DEPARTMENT OF PLANNING
STAFF REPORT

DATE OF HEARING: December 1, 2010

ZMOD-2010-0002; Webb Buffer Easement

H-6

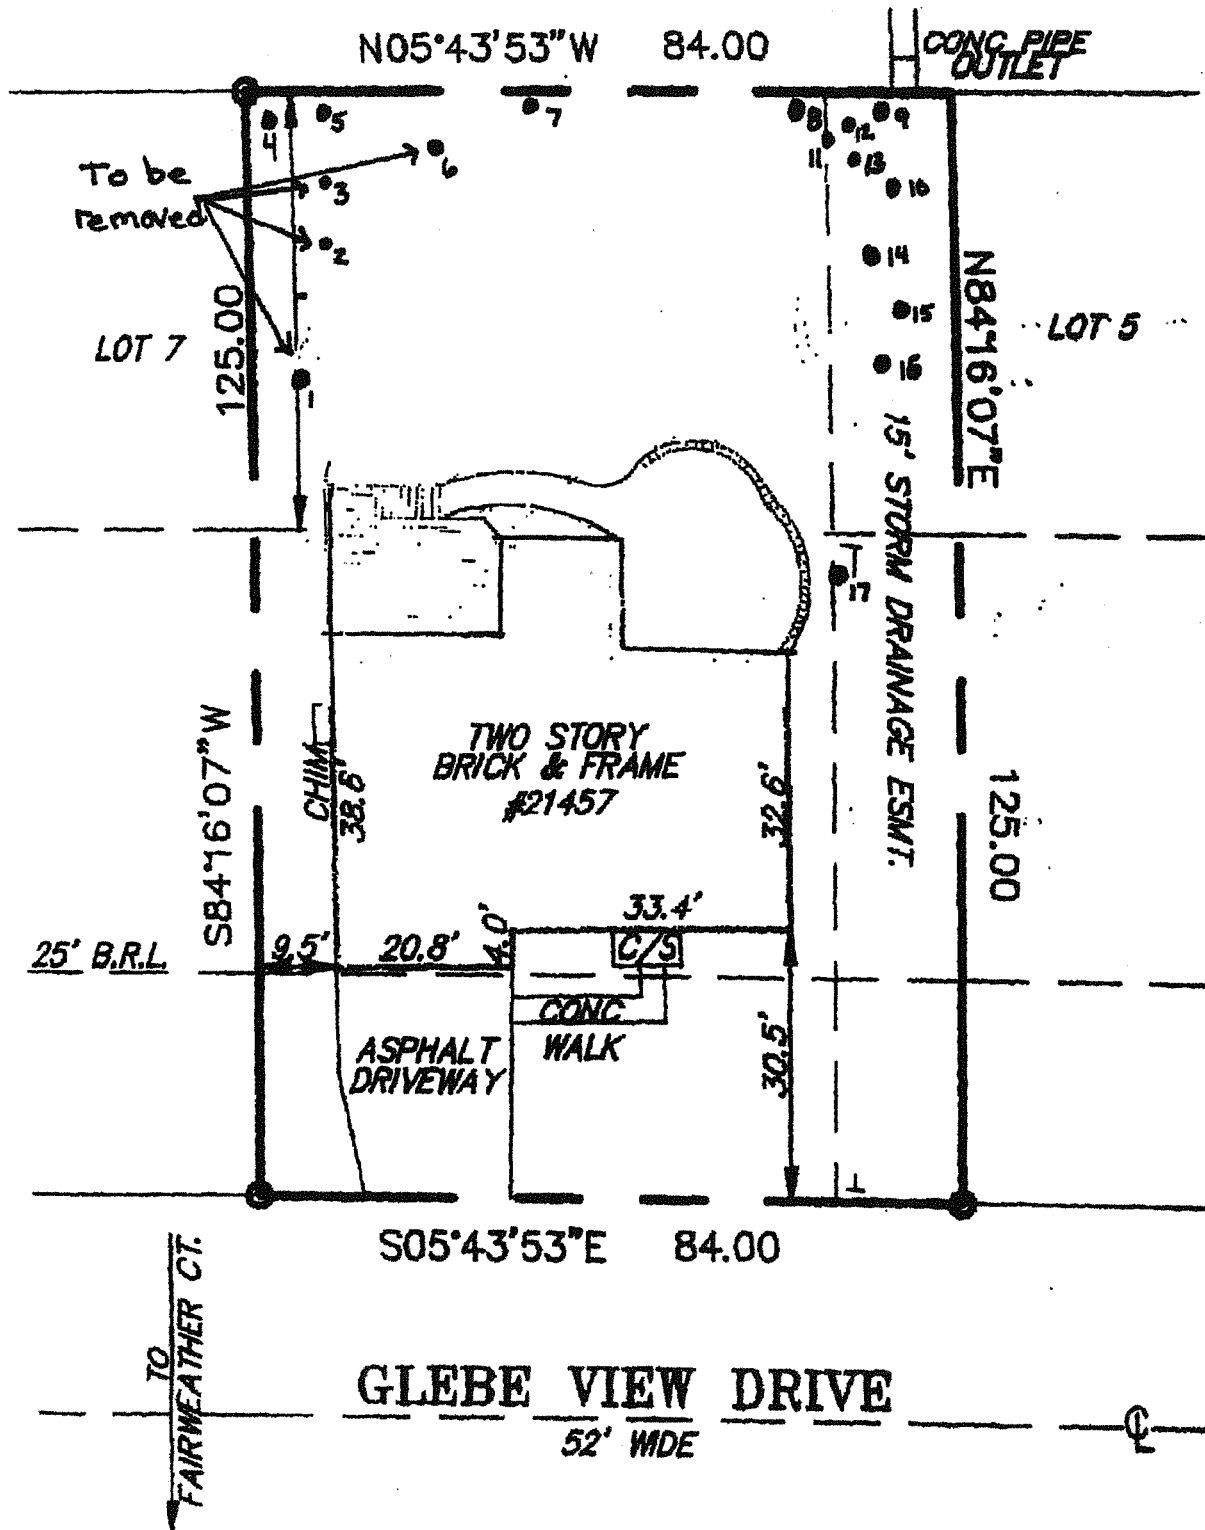
**Trees 1, 2, 3 and 5 need to be removed to accommodate pool/construction. Four new trees will be planted at the conclusion of the project.*

POOL PLAT

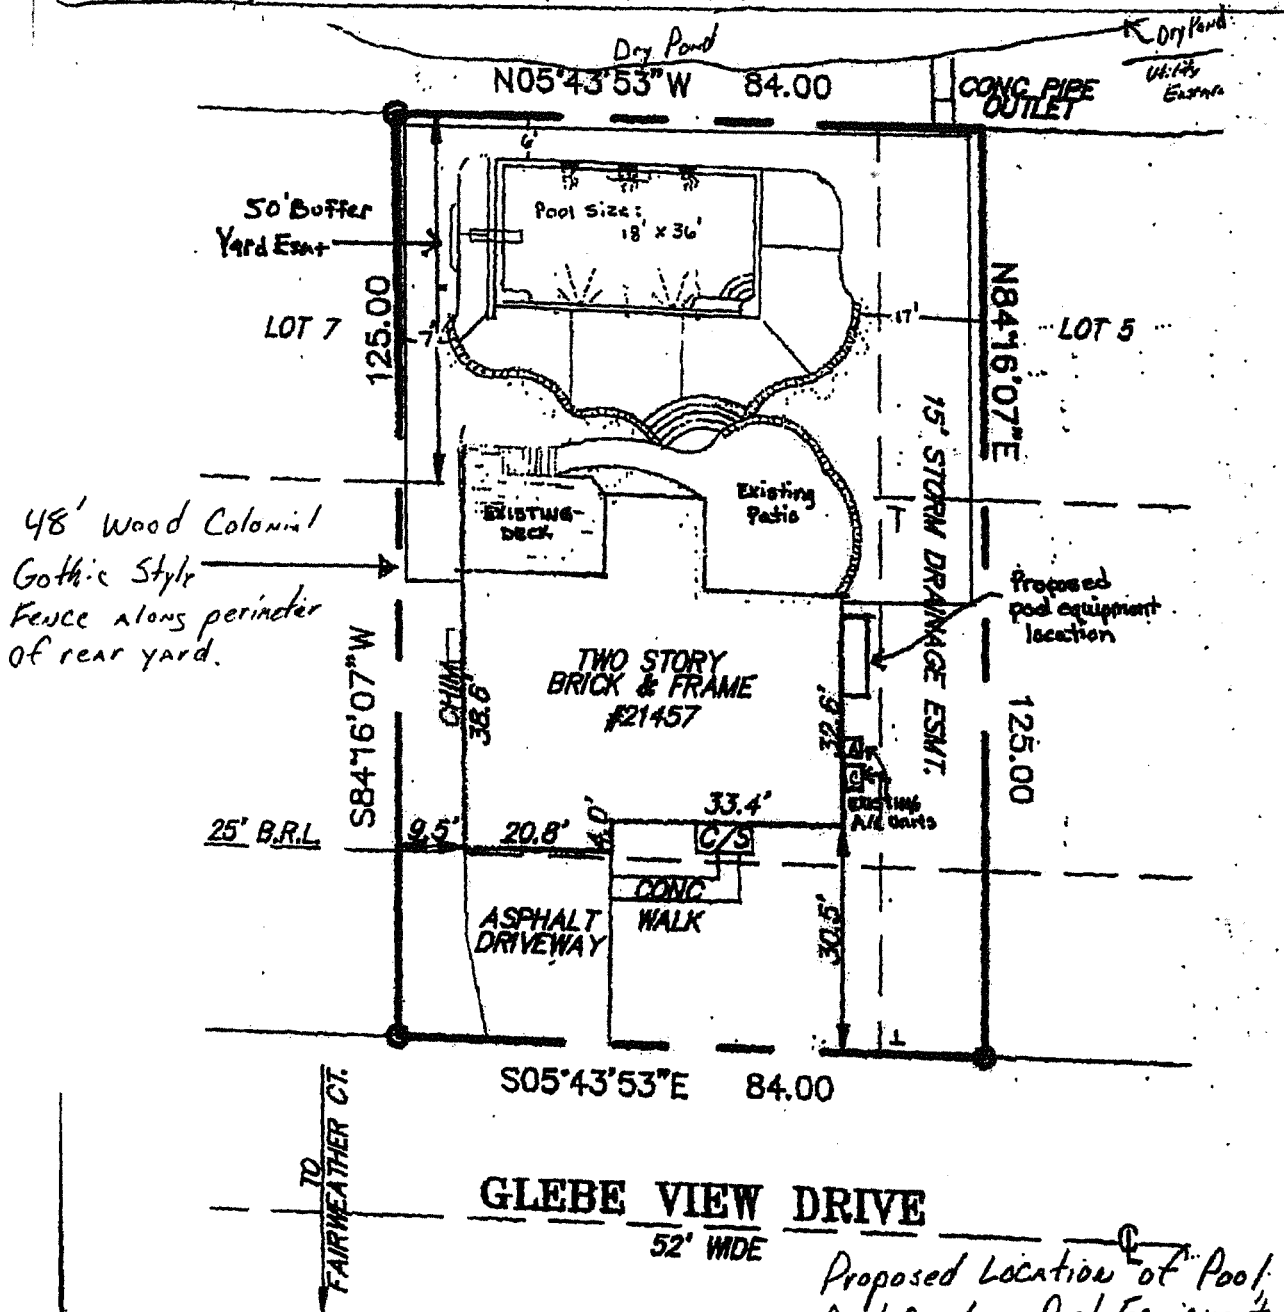
1. Conformance The modification of the buffer yard shall be in substantial conformance with the Pool Plat dated November 8, 2010 and the Landscape Plan dated November 8, 2010 and the applicable Loudoun County Zoning Ordinance. The Approval of this application for Tax Map /78//50/////6/ (PIN #155-27-4004) (the "Property") shall not relieve the applicant or owners of the Property from the obligation to comply with and conform to any other Zoning Ordinance, Codified Ordinance, or applicable regulatory requirement.
